Department of Planning, Housing and Infrastructure

This document provides responses to the traffic and transport related matters raised by the City of Sydney Council (Council) in their submission to the site at 13-17 Oxford Street and 2 Verona Street, Paddington (SSD – 87245208). The Council submission is dated 5 May 2026.

**Table 2: Responses to Council comments**

**Drawing No**  
 2268\_04

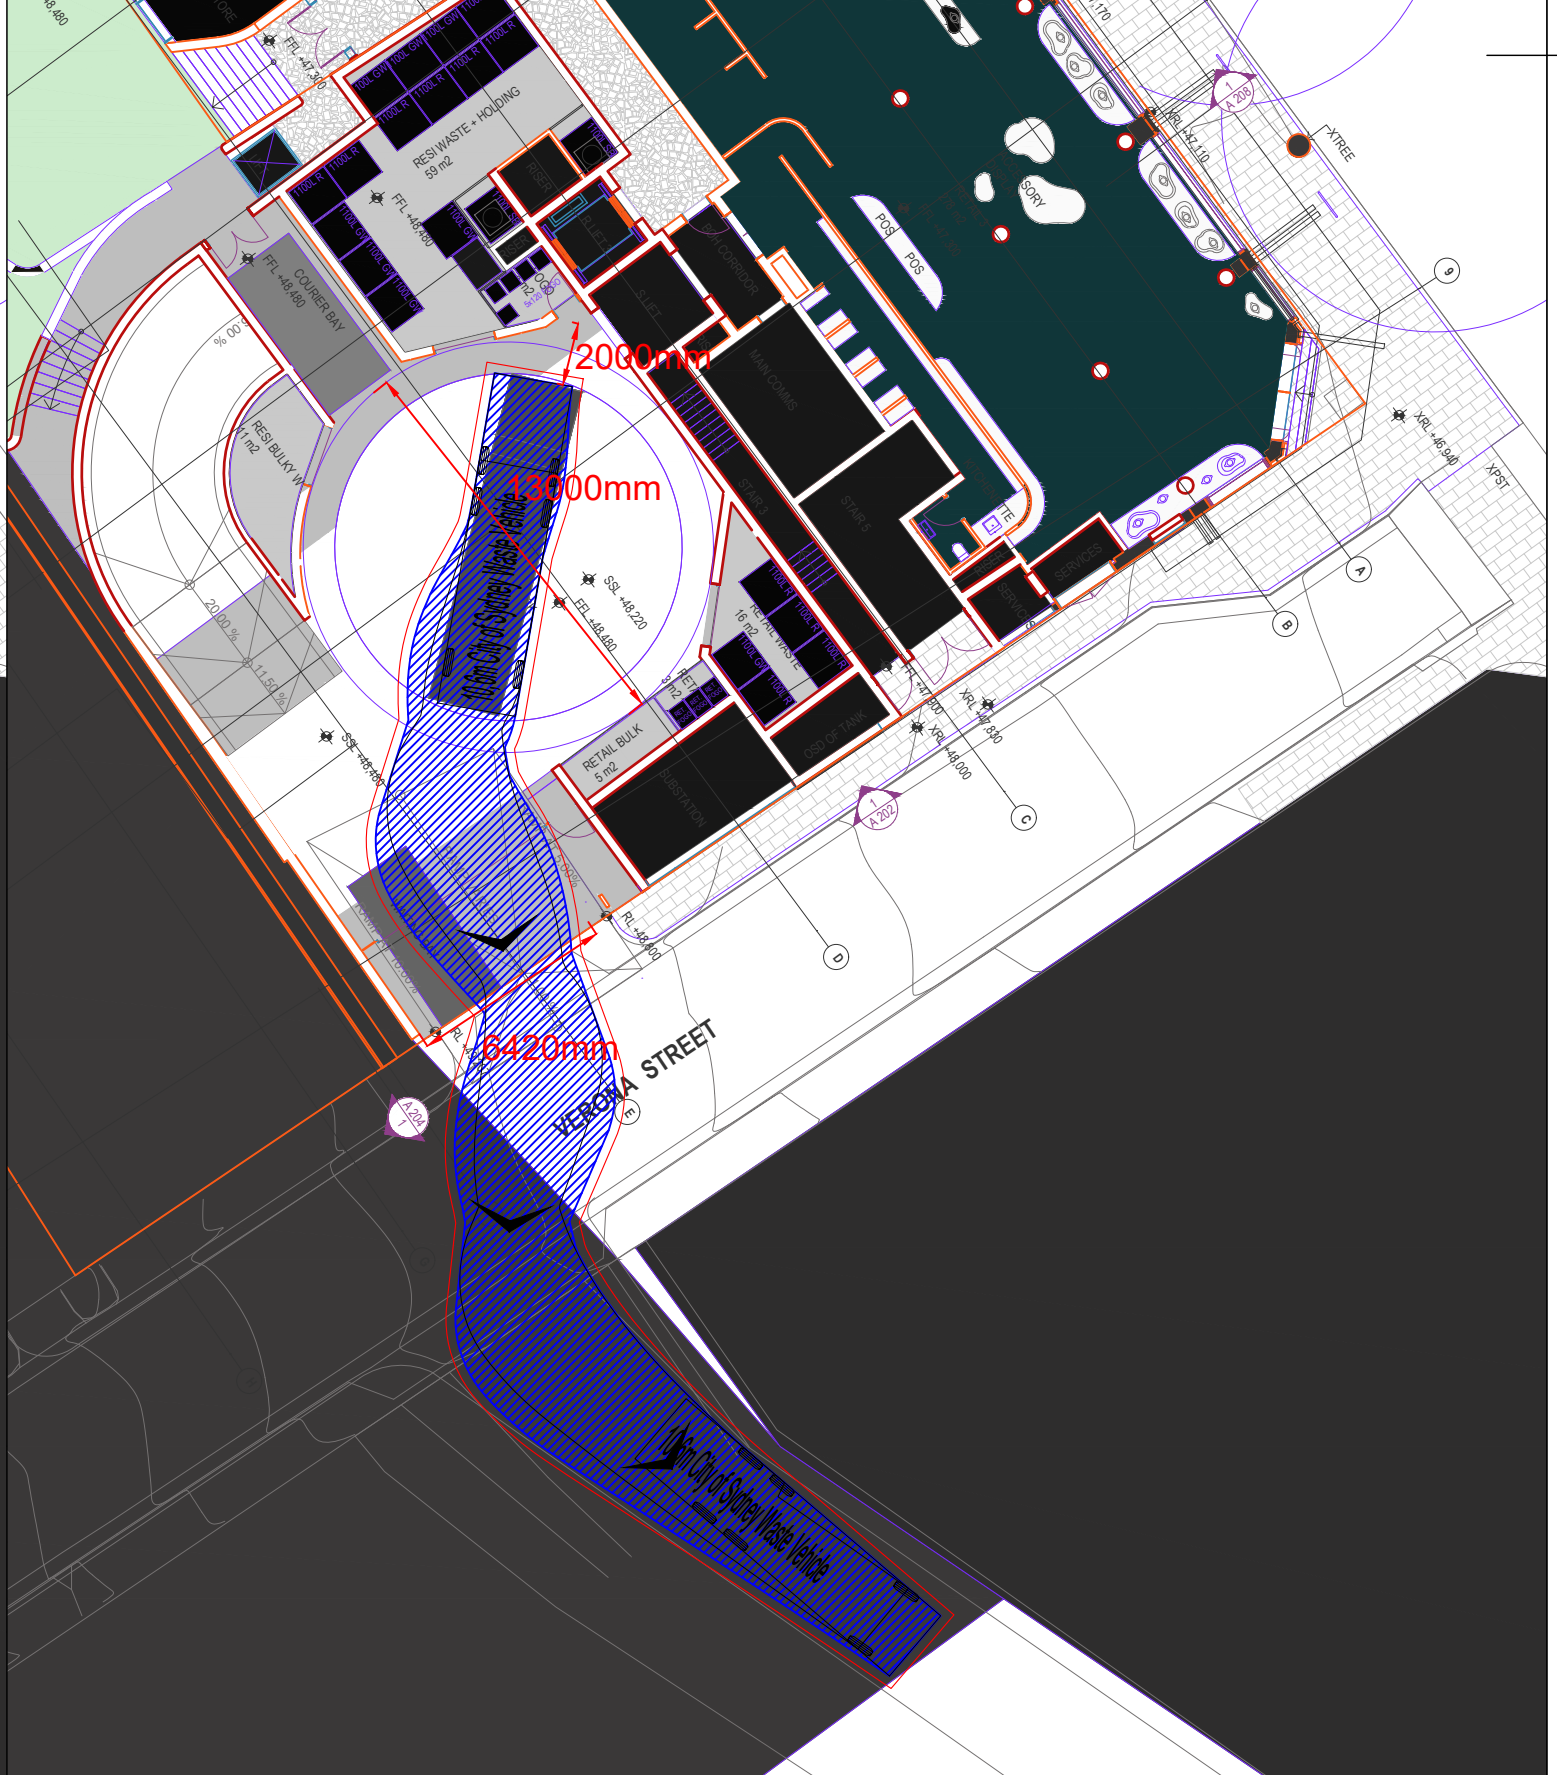
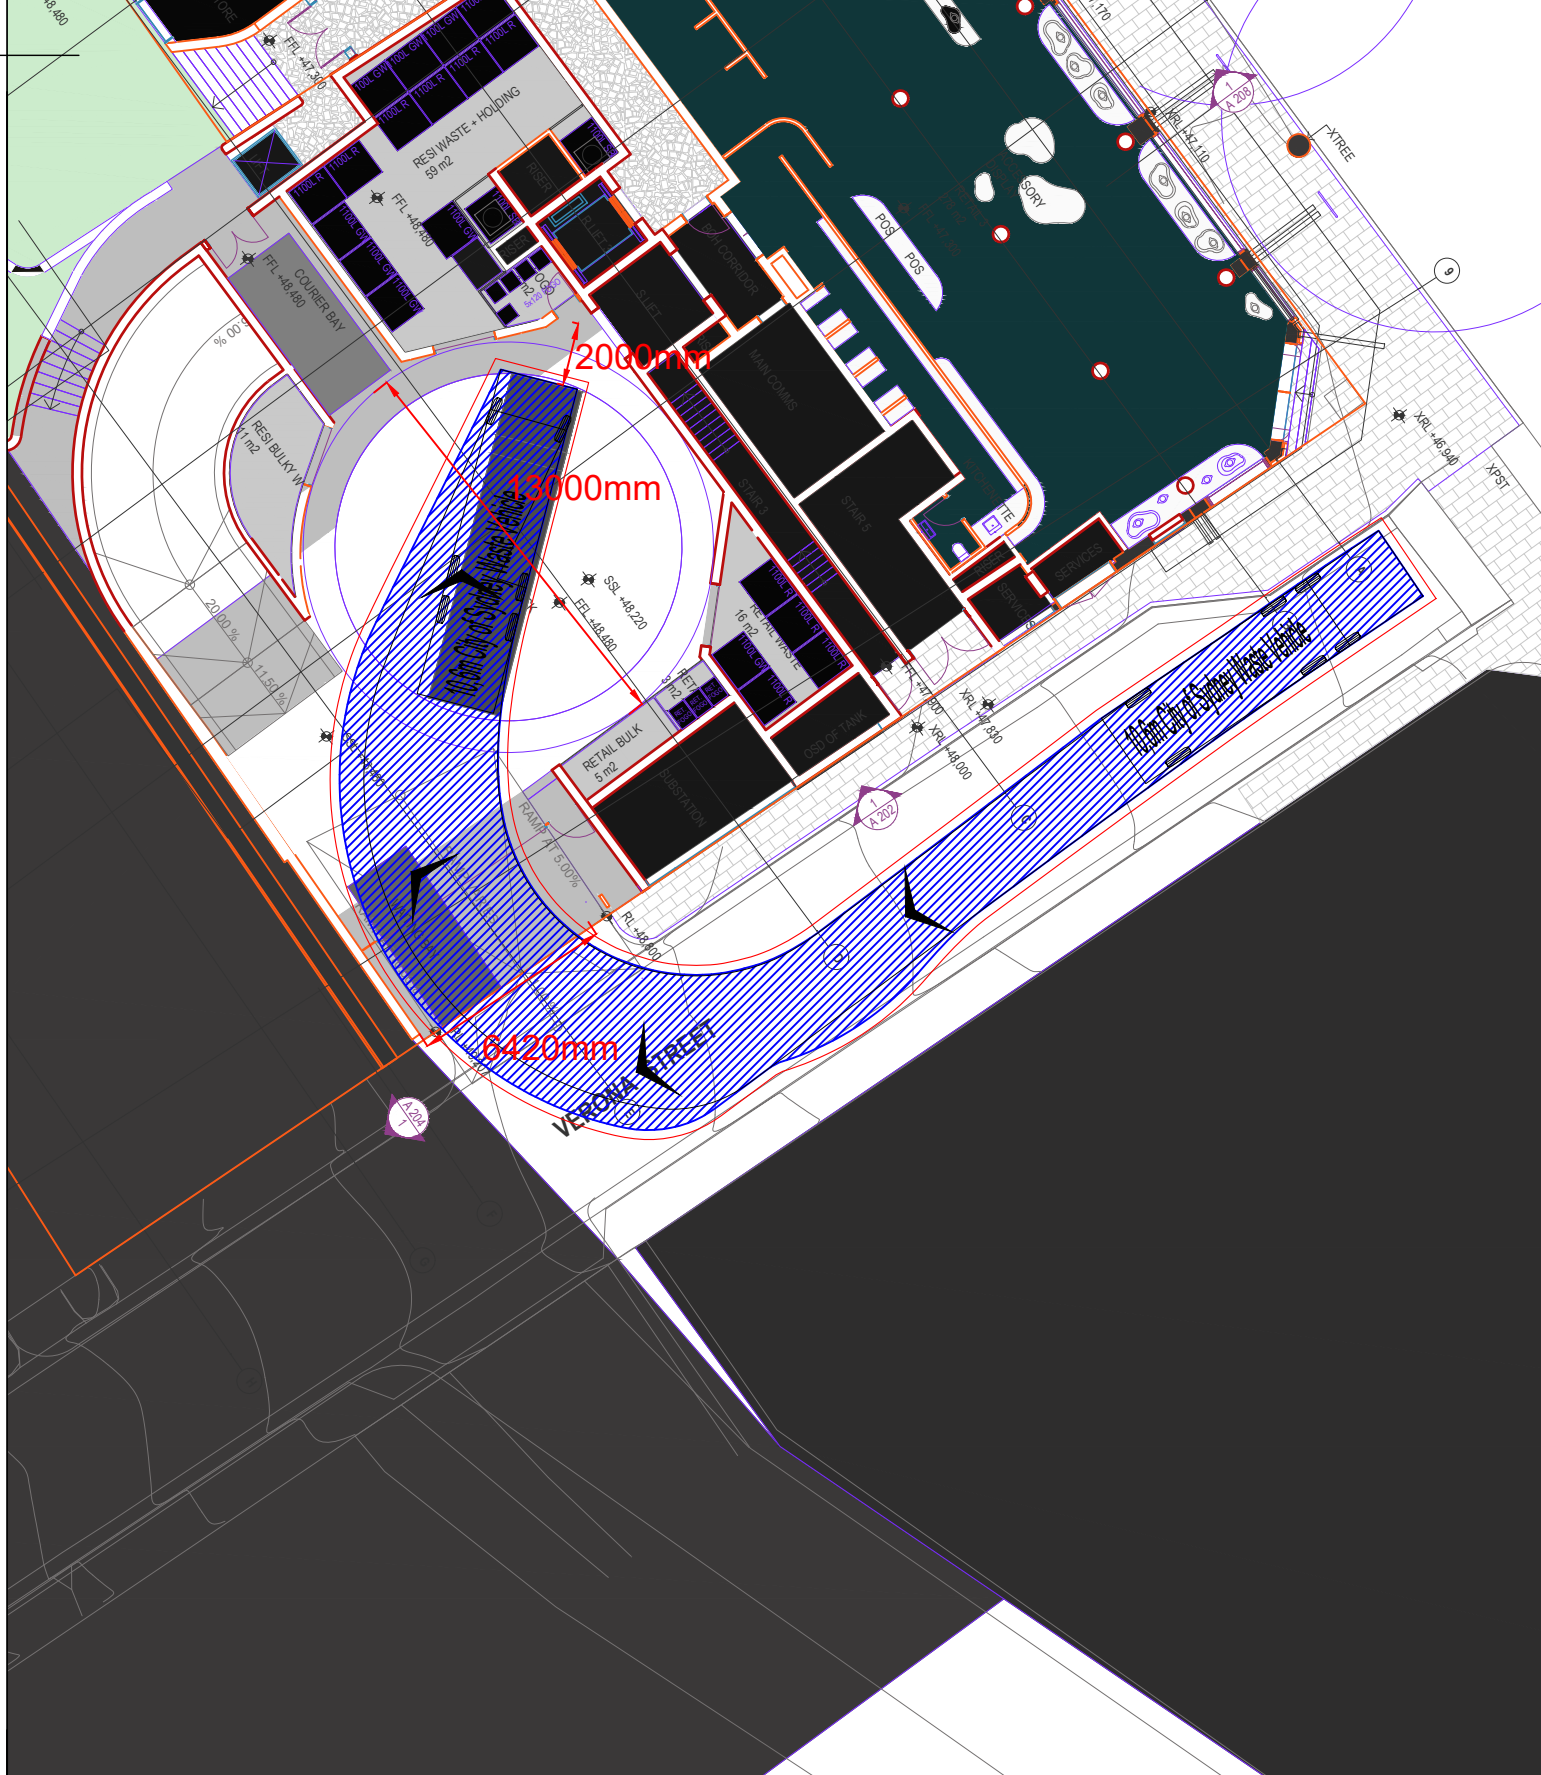
CoS Item Number	Council Comment	JMT Consulting Response
12.2	<p><i>Vehicle access and car park design</i></p> <p>The following outstanding information and amendments are required regarding the proposed vehicle access and car park design:</p> <ul style="list-style-type: none"> <li>i. Updated swept paths of the revised 6.5m driveway design.</li> <li>ii. The revised plans show the gradient along the vehicle ramp to/from Verona Street varies from 5% to 10% (previous documentation stated 5% grade). This does not comply with AS2890 series and introduces an unacceptable crossfall for heavy vehicles.</li> </ul> <p>Gradients must not exceed 5% for 6m prior to the building line and the maximum rate of change of grade is 6.25%. The driveway ramp must be updated to provide a compliant ramp grade, grade transitions and crossfall for heavy vehicles.</p>	<ul style="list-style-type: none"> <li>i. Swept paths for the driveway, including for passenger vehicles and a 10.6m City of Sydney waste truck, are provided as Appendix B of this document</li> <li>ii. AS2890.1 requires a maximum gradient of no more than 5% so as to allow exiting drivers to adequately view pedestrians and vehicles on the adjoining roadway. Therefore this requirement applies to exiting vehicles.</li> </ul> <p>The proposed design complies with this requirement by providing for a gradient of 5% on the path of the exiting vehicle – noting the entering vehicle (on the southern side of the driveway) will be positioned on an internal waiting bay. This is indicated in the swept paths provided as Appendix B of this document. All internal ramp gradients and transitions as submitted in the architectural plans comply with the relevant requirements of AS2890.1.</p> <p>The comment around the crossfall of the ramp is noted, however Council must recognise that Verona Street falls sharply from south to north resulting in different starting levels at either end of the ramp. In this context a crossfall on the internal ramp is unavoidable.</p> <p>The vehicle entry arrangements including swept paths and ramp crossfalls will be the subject of further design resolution during the detailed design phase of the project, with sign off from a suitably qualified engineer required to confirm the layout conforms with the requirements of AS2890.1 prior to the issue of a Construction Certificate.</p>
